Service Provider Letter

Jurisdiction: City of Sherwood **Review Type:** Tier 2 Analysis
Site Address / Location: 15665 SW Willamette ST **SPL Issue Date:** December 28, 2021
Sherwood, OR 97140 **SPL Expiration Date:** December 28, 2023

Sherwood Oldtown Apartments

FIGURE 4

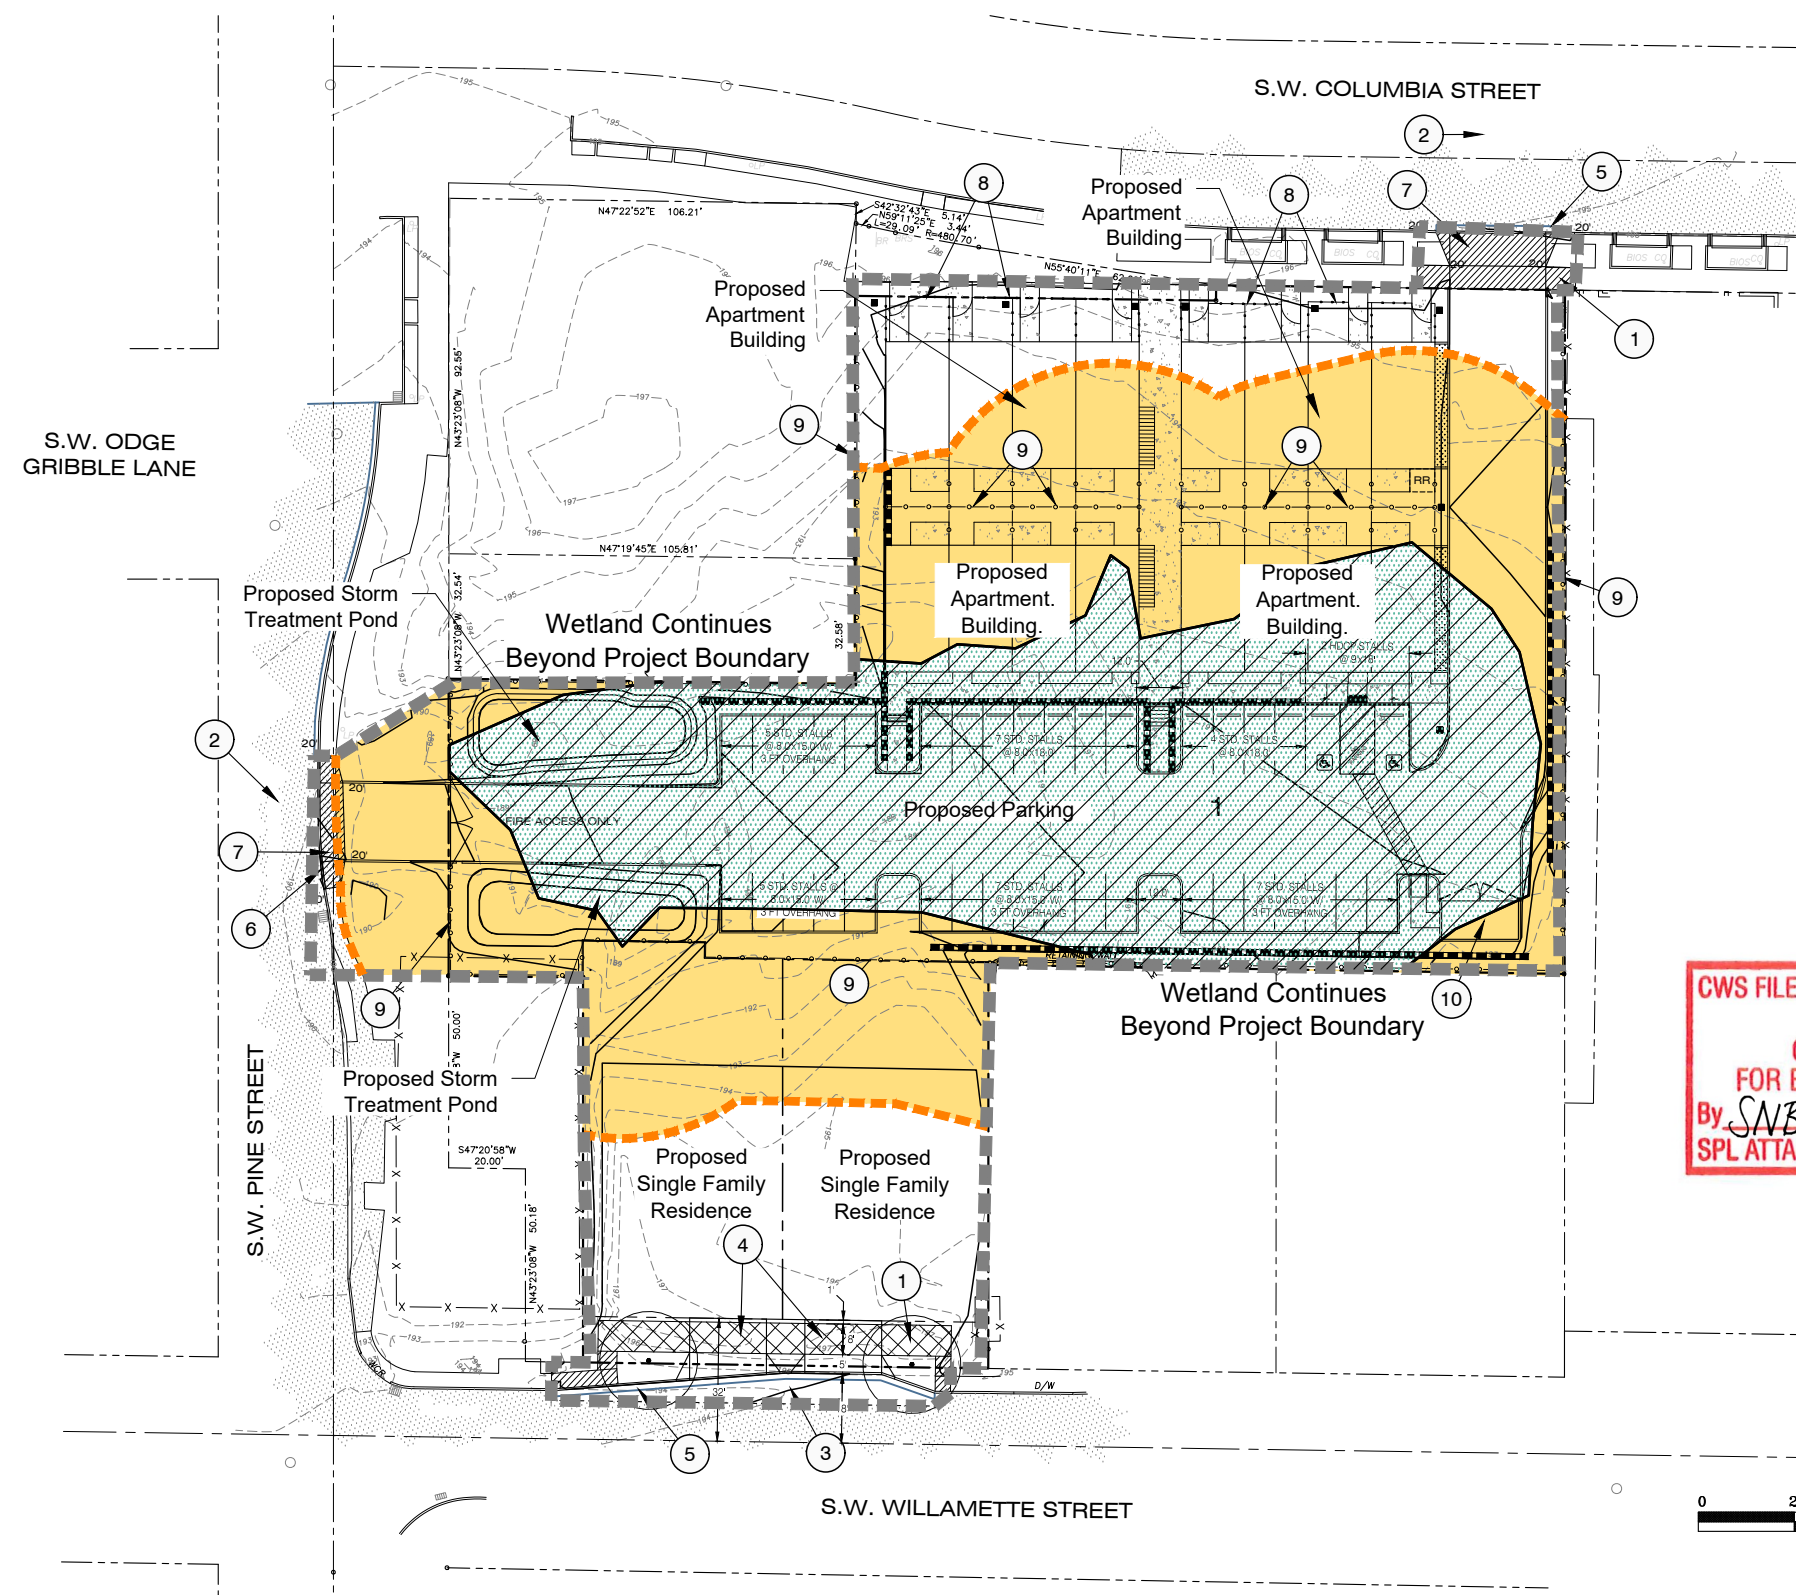
| <u>Apartments, parking, stormwater treatment (Permanent Encroachment; Mitigation Required)</u> | <u>21,040</u> |

| <u>Per R&O 13-12 Mitigation for Vegetated Corridor Impacts Associated with Wetland Fill is met with Purchase of Wetland Mitigation Bank Credits</u> | <u>21,040</u> |

NOTE:
Vegetated Corridor Encroachments will be mitigated through Credit purchase at DSL/COE Approved Wetland Mitigation Bank
